Our Reference: **PT23061**

7 June 2024

**28 to 32 Bourke Road, Alexandria Health Centre Stage 2 SSDA
Response Report to Request for Information**

L00 - GF - CAR PARK
1:125

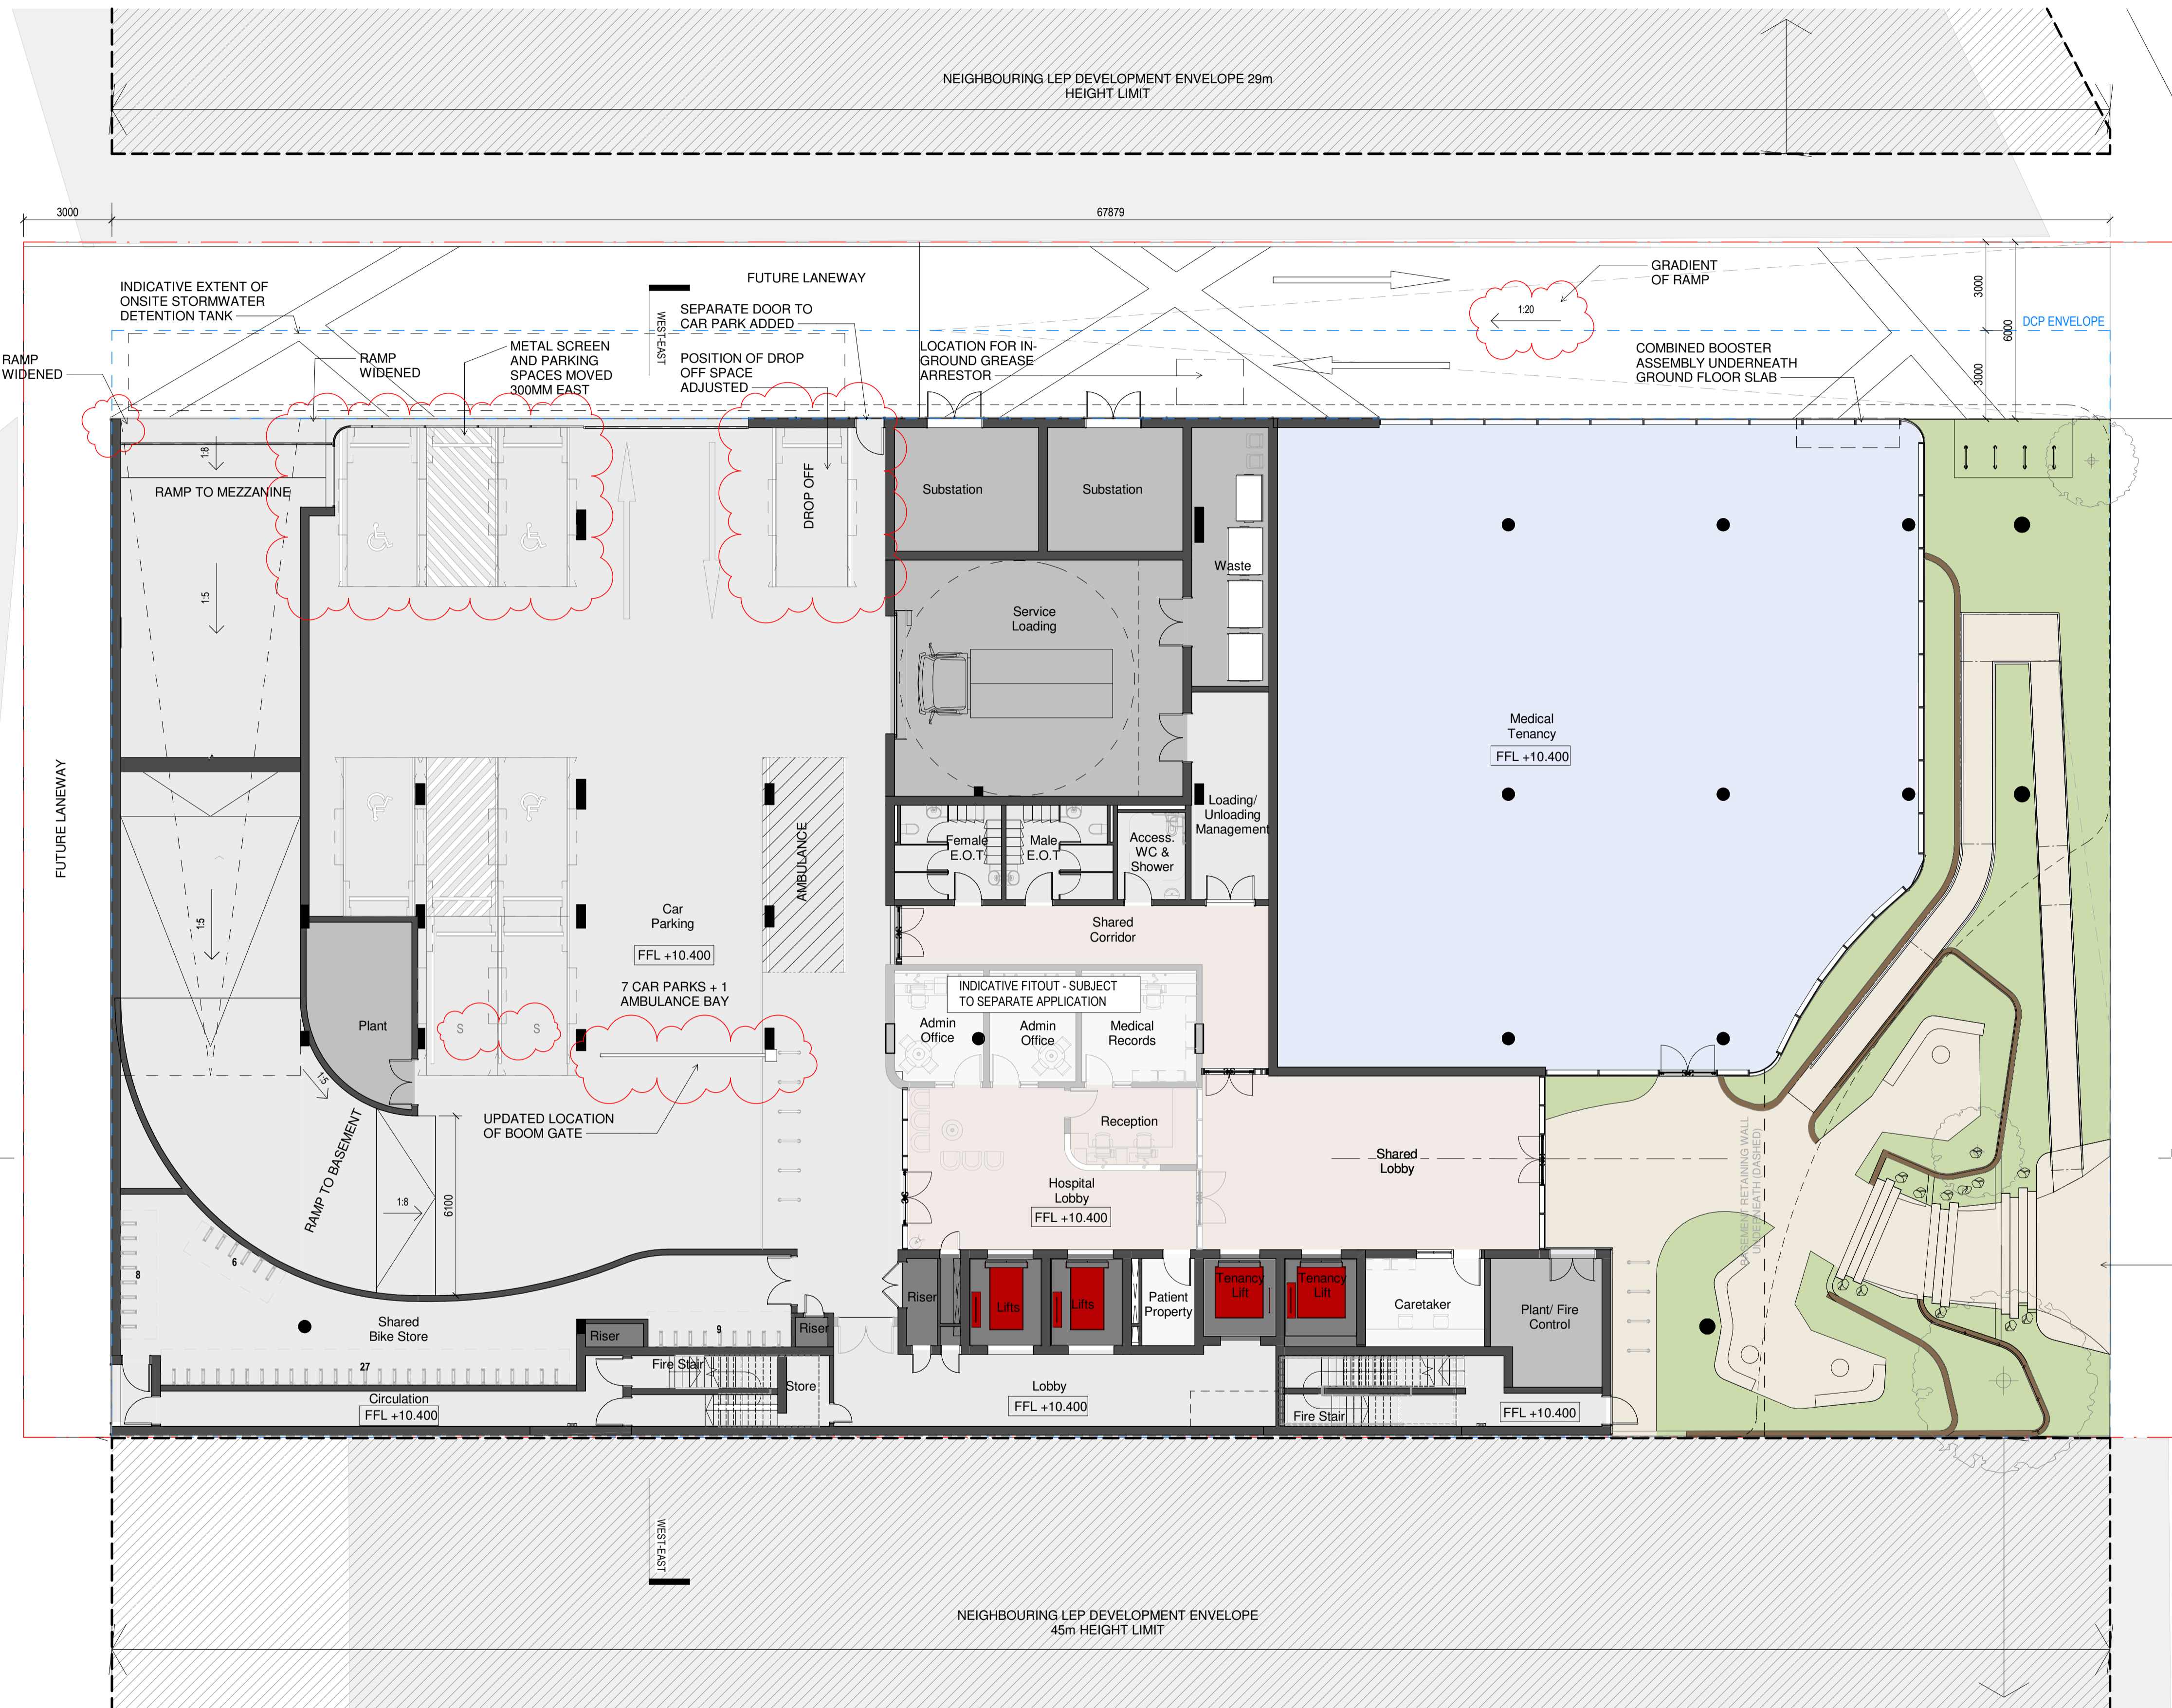
5d	It is recommended that clarification be provided if the 4 x accessible car parking spaces will be allocated to staff.
----	---

5f	It is recommended that the door opening zone for accessible car spaces be located away from vehicle traffic.
----	--

The four accessible spaces, which equates to approximately 5% of the total parking provision, which is generous, would be publicly available at all times and also used by those staff who require access to an accessible parking space.

The boom gate control has been relocated further into the ground floor to ensure access to accessible spaces at all times.

All door opening zones of accessible parking spaces on the ground floor open inward to the central area of each pair of parking spaces. Further, only informed drivers (staff) would travel past these accessible spaces.

DA_L0M - MEZZANINE GENERAL ARRANGEMENT

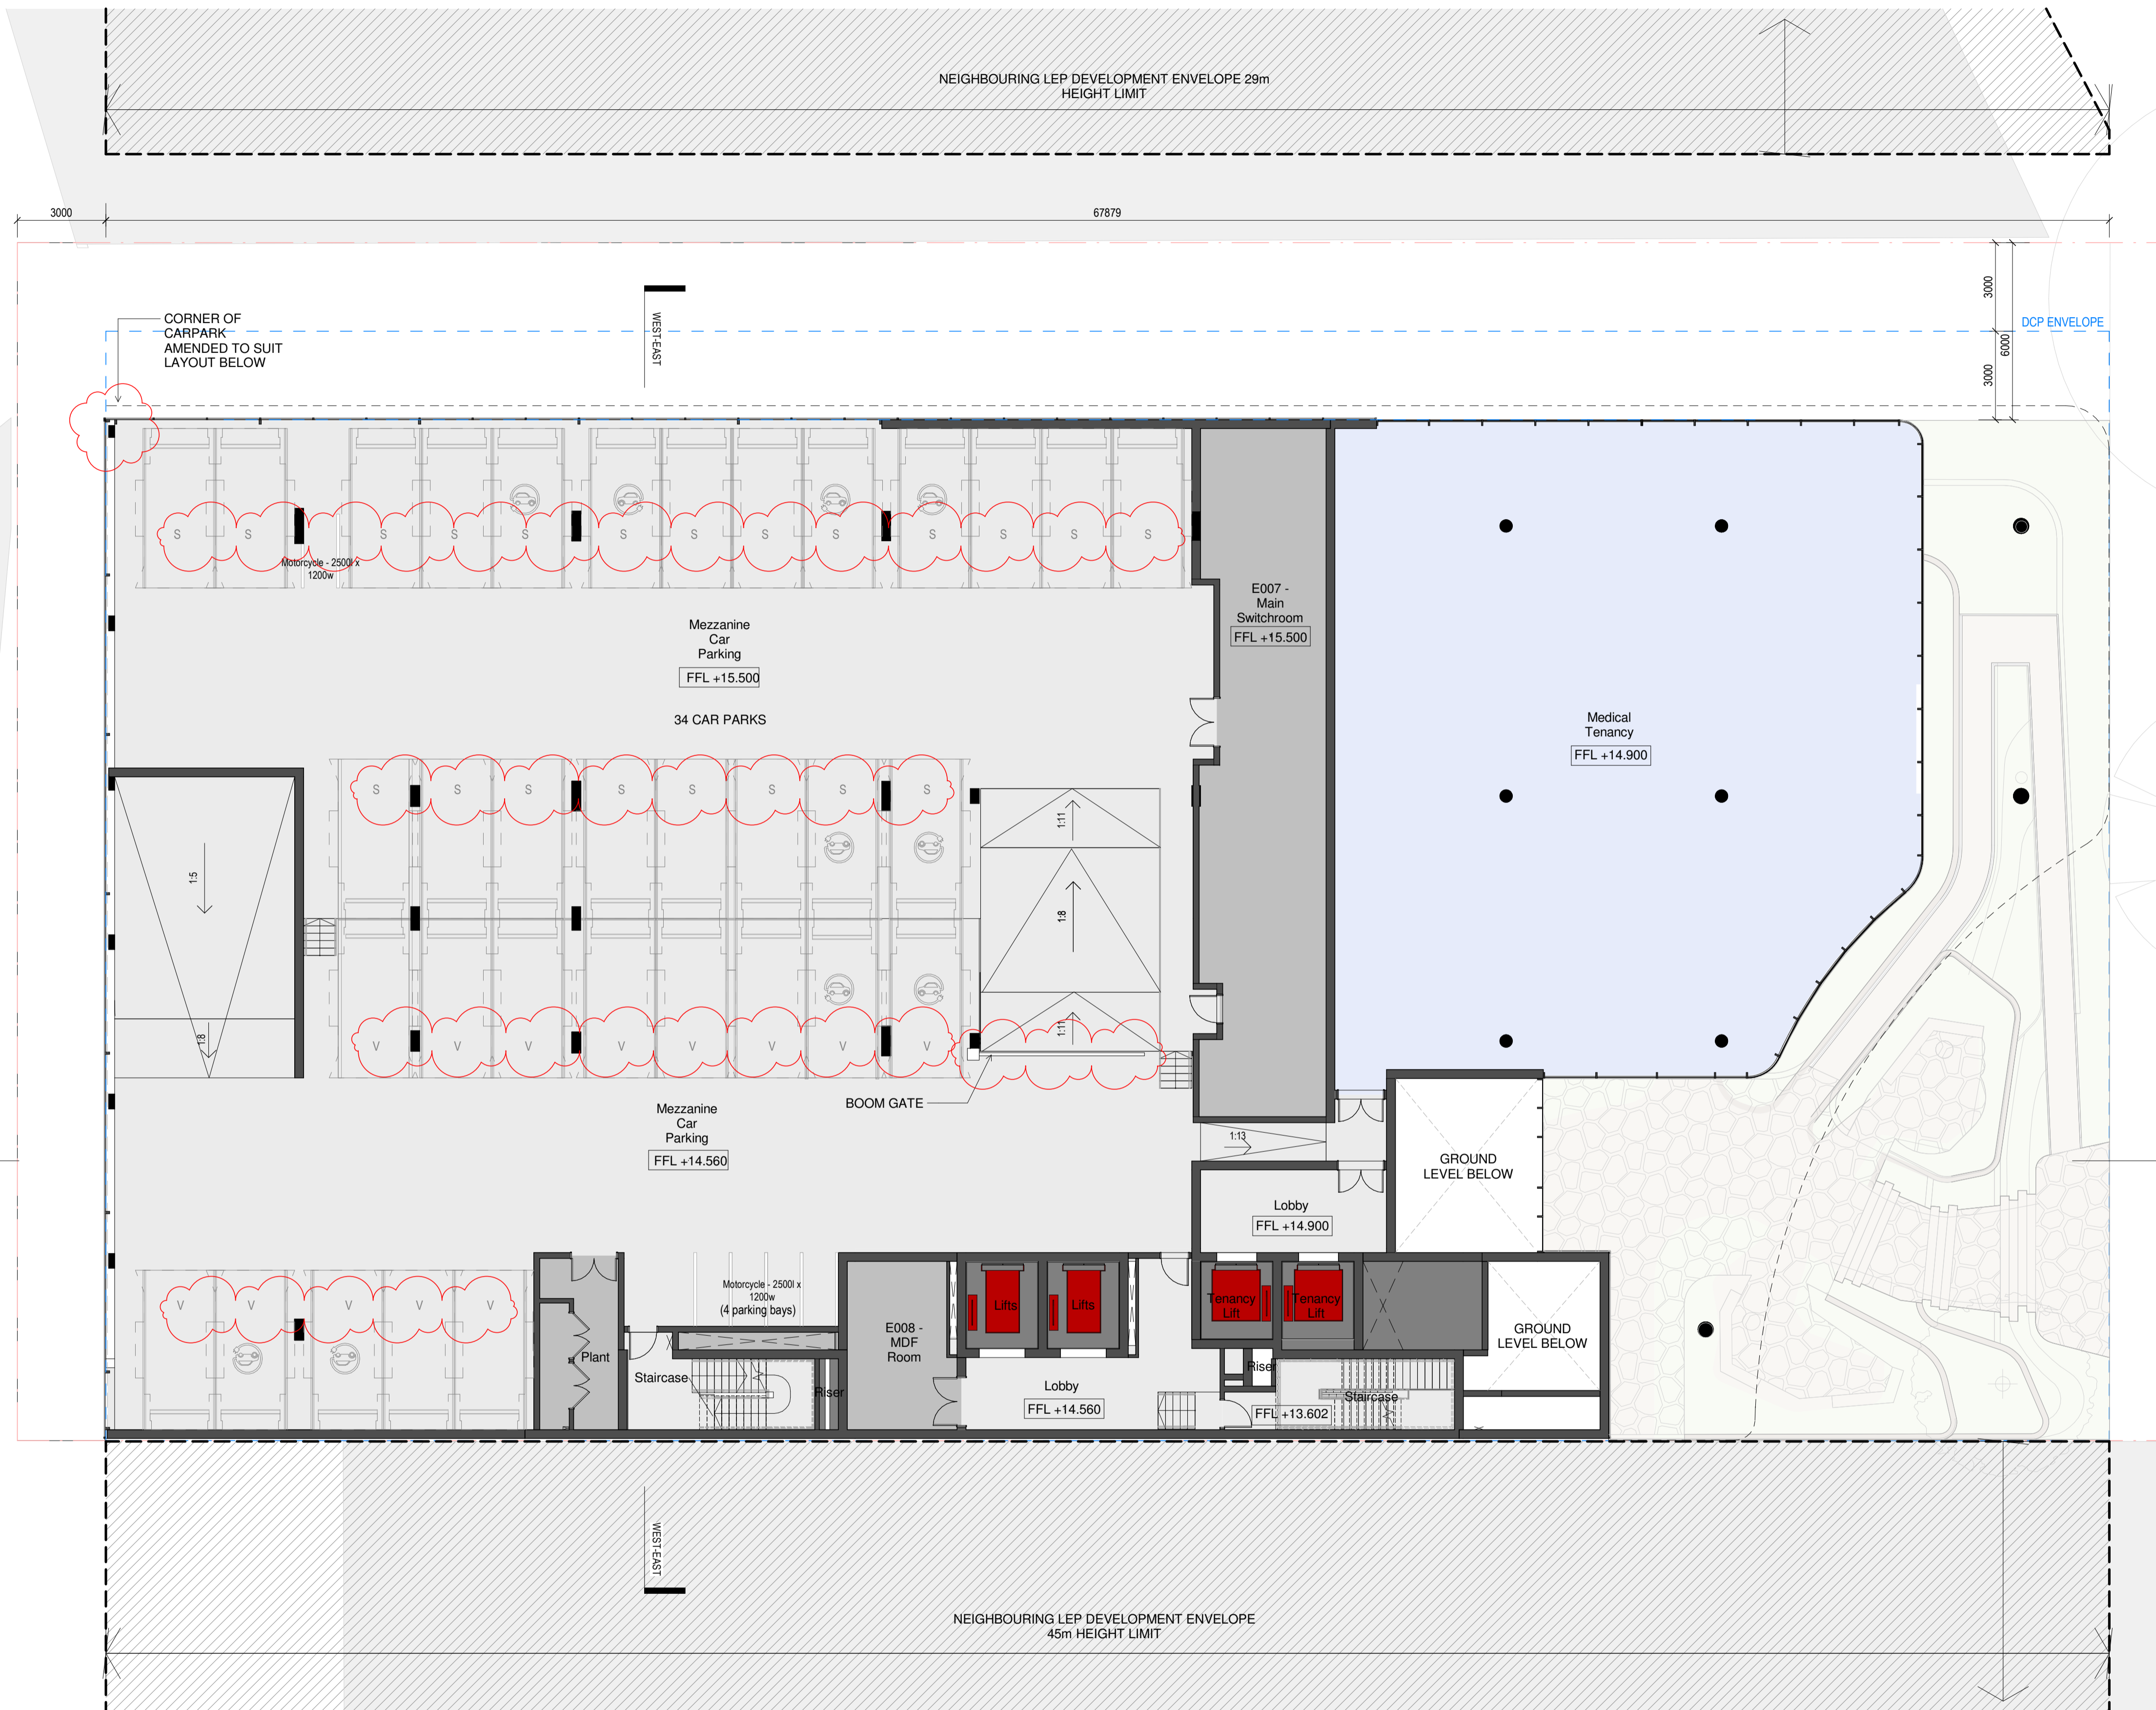
5e	It is recommended that the mezzanine and basement level car park levels be provided with a turning bay/blind aisle
----	--

The new arrangements of staff / public parking negate the need for turnaround bays as all aisles of car parking which form a cul-de-sac would be classified as 'private' (staff only) parking of which Clause 2.4.2 c) of AS2890.1 would not apply. That is, turn around bays are only required in car parks which include blind aisles greater in length than six (6) car spaces access by the *public*.
